Municipal Planning Commission

Development Permit Report

DATE OF MUNICIPAL PLANNING COMMISSION MEETING: August 31, 2023			
FROM:	Planning & Development	WARD:	Erskine – Buffalo Lake
OWNER:	2066052 Alberta Ltd., o/a Bar W Resort	APPLICANT:	2066052 Alberta Ltd., o/a Bar W Resort
SUBJECT PROPERTY:	NE 20-40-20-4	ZONING:	Recreational Facility District (RF)
TOTAL AREA IN EXISTING TITLE:	79.29 acres (32.10 hectares)	PROPOSED DEVELOPMENT:	Recreational Vehicle Park and Rural Convenience Store
FILE NO:	DP 23077	ROLL NO.	581400

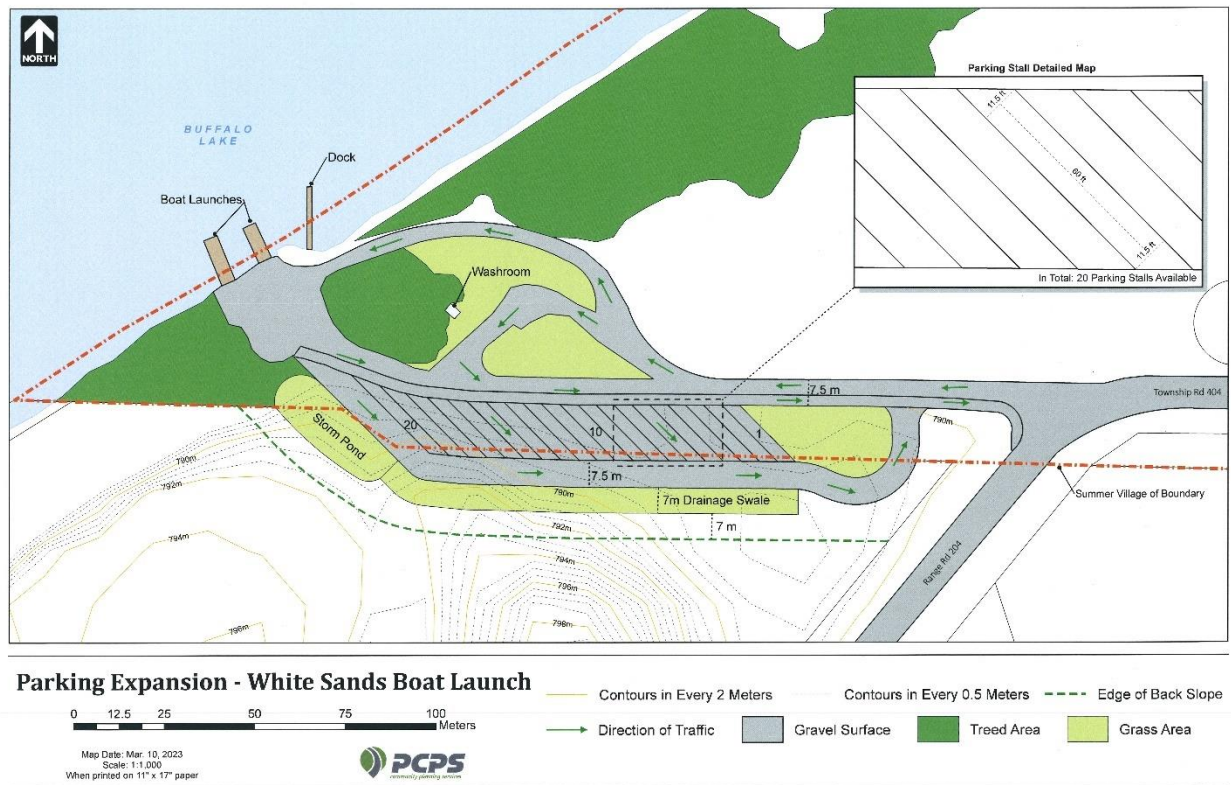
Earlier in 2023, the County and Summer Village of White Sands had initial discussions on improving the White Sands boat launch by expanding the area available for parking of trucks and boat trailers. The concept below shows how 20 pull through parking spaces could be added to the site and work with the existing terrain and vehicle circulation pattern. Collaboration between the County, and the Summer Village (who owns the boat launch and has jurisdiction over the site) will be needed and several details remain to be worked out. Additional land to the south is needed to construct the expanded parking and a process would need to be put in
